## SERVICE BULLETIN

**APPLICABILITY:** 2013-19MY BRZ

**NUMBER:** 09-54-12R

**SUBJECT:** High-Pitched “Chirp,” “Squeak” or “Cricket”  
 Sound from the Engine

**DI FUEL PUMP ASSEMBLY**

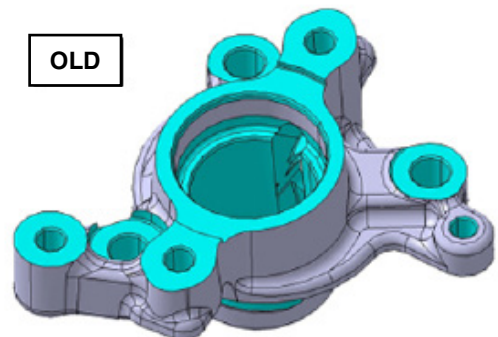
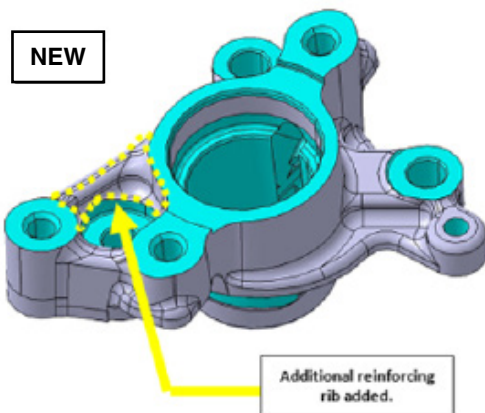
**Top View of New (Flat Top Plate) High-Pressure Fuel Pump**

Identifying the most up-to-date pump from previous versions using the numbers found on the Top Plate:

- **For Production Line installed Pump:**  
Current and Previous (both): 16625JB000  
Current: 296100-0291 Previous: 296100-0290
- **For Replacement / Service / Repair Part:**  
Current: 16625JB022 Previous: 16625JB021  
Current: 296100-0491 Previous: 296100-0490

**PUMP DRIVE CASE ASSEMBLY (Check Table Above for Applicability)**

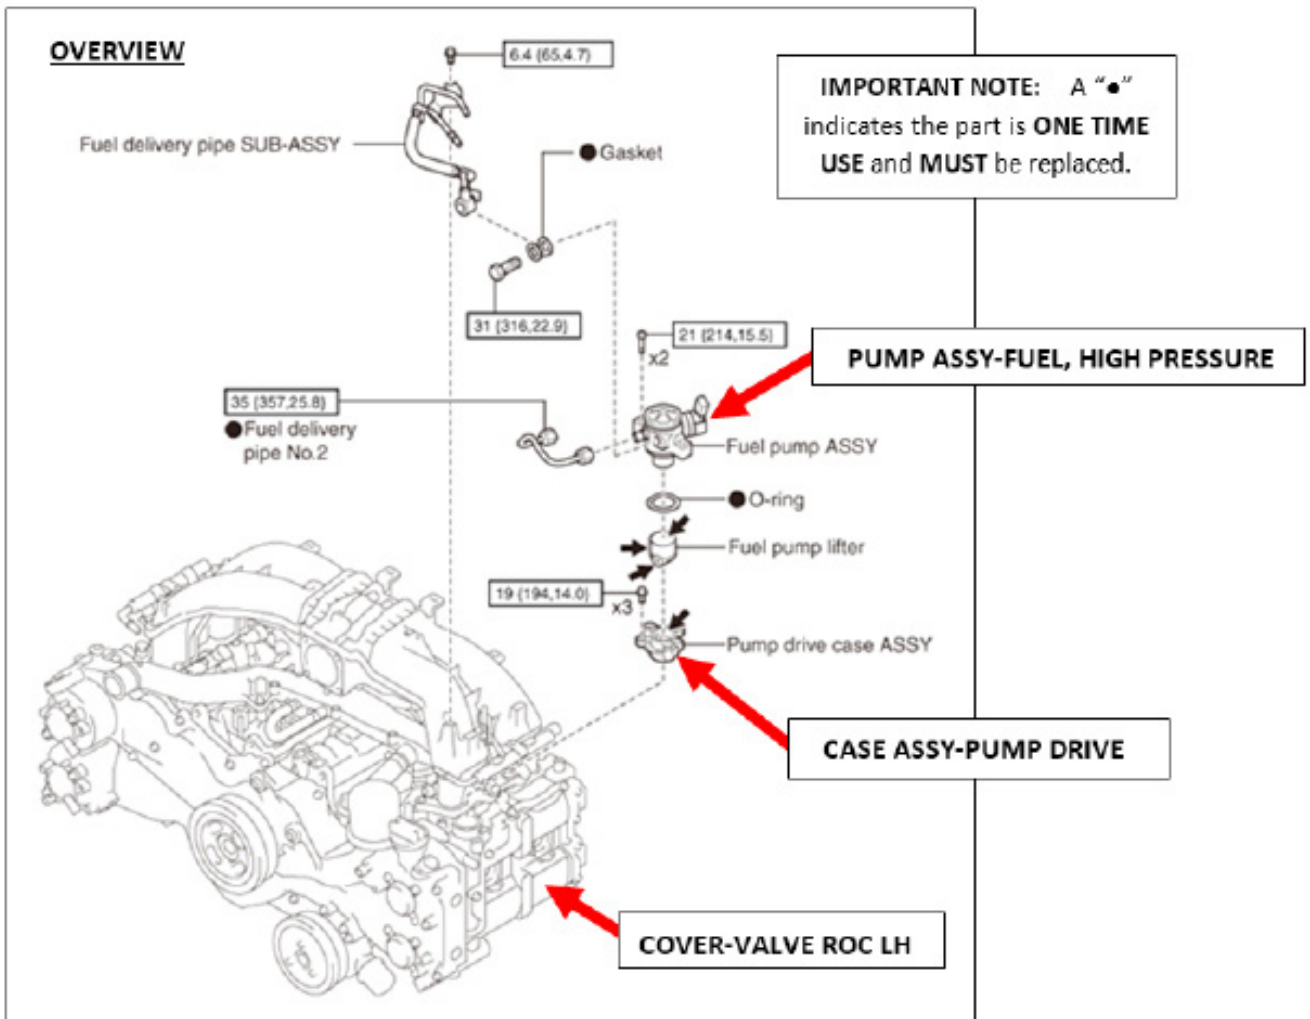
VIN RANGE	REQUIRED PART REPLACEMENT(S)		
	DI Fuel Pump	Drive Case	Rocker Cover LH
Prior to F*603025	YES	YES	YES
F*603026 to F*603363	YES	NO	YES
F*603364 to G*604648	YES	NO	NO
